## **Manual Supplement**

Manual Title: 345 Users Supplement Issue: 2
Part Number: 2560401 Issue Date: 3/08
Print Date: October 2006 Page Count: 1

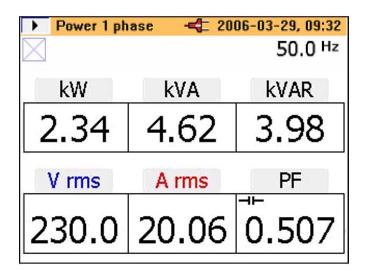
On page 55, replace the screen shot with the following:
